# Comments on IEEE Draft P802.3cg/D1.0

Dayin XU  
Rockwell Automation  
January, 2018

Figure 146-4—PCS transmit state diagram

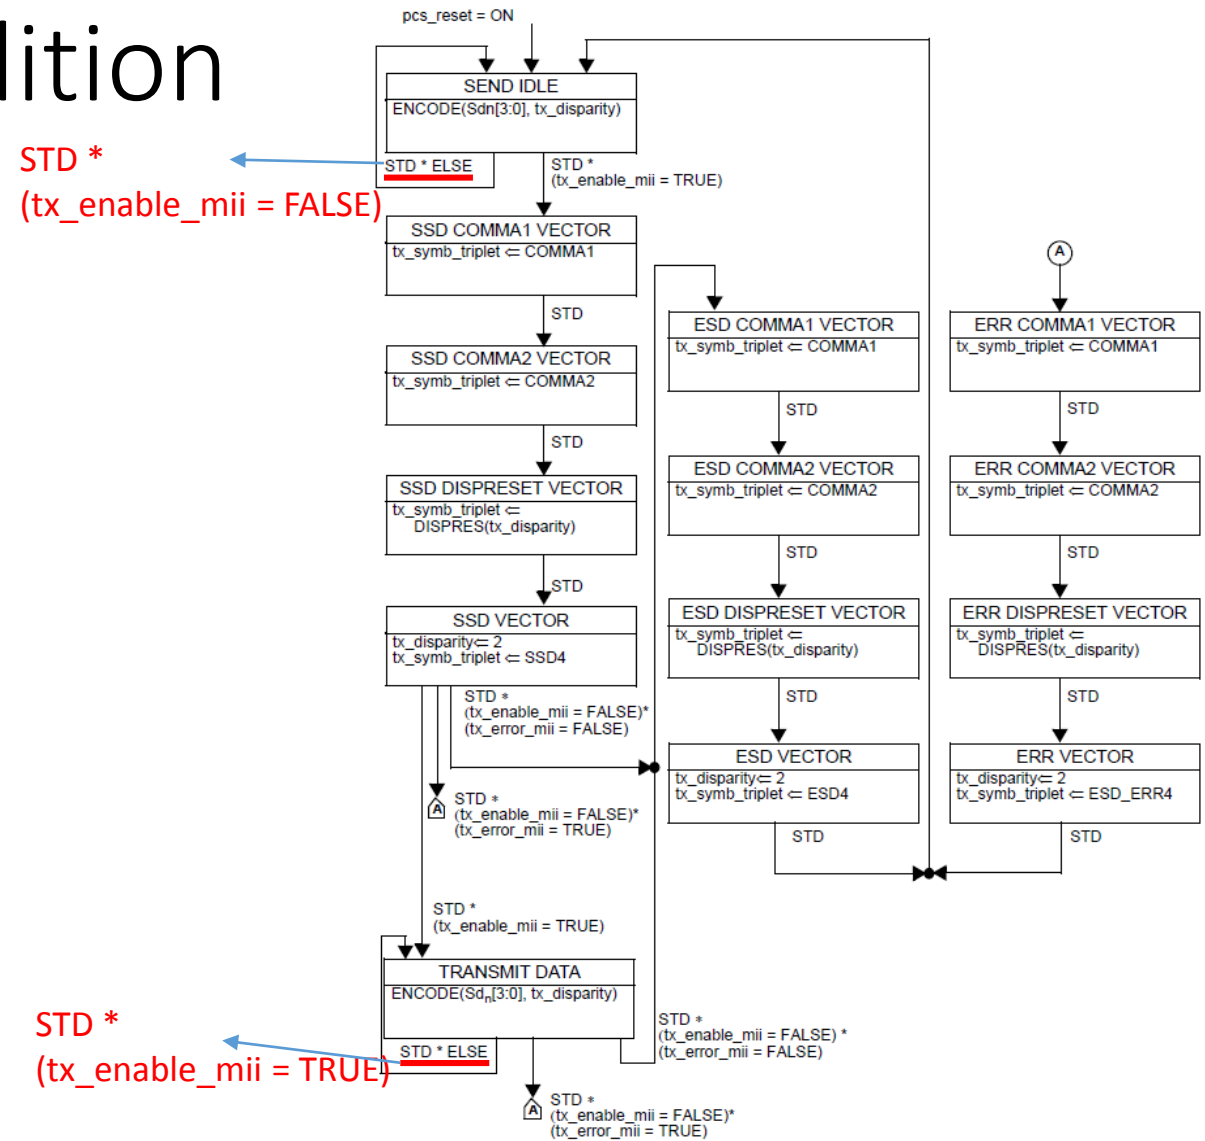
- Where
  - page 95, figure 146-4, Clause 146.3.3.1
  - Many other figures
- Comment
  - The transition condition "STD \* ELSE" for the State "SEND\_IDLE" and "TRANSMIT DATA" is not expressed explicitly. The same comment applies to other figures. Task Force needs to discuss this and determine whether this "ELSE" style is OK or not before taking any action
- Proposed change
  - Change all “ELSE” condition to explicit expression
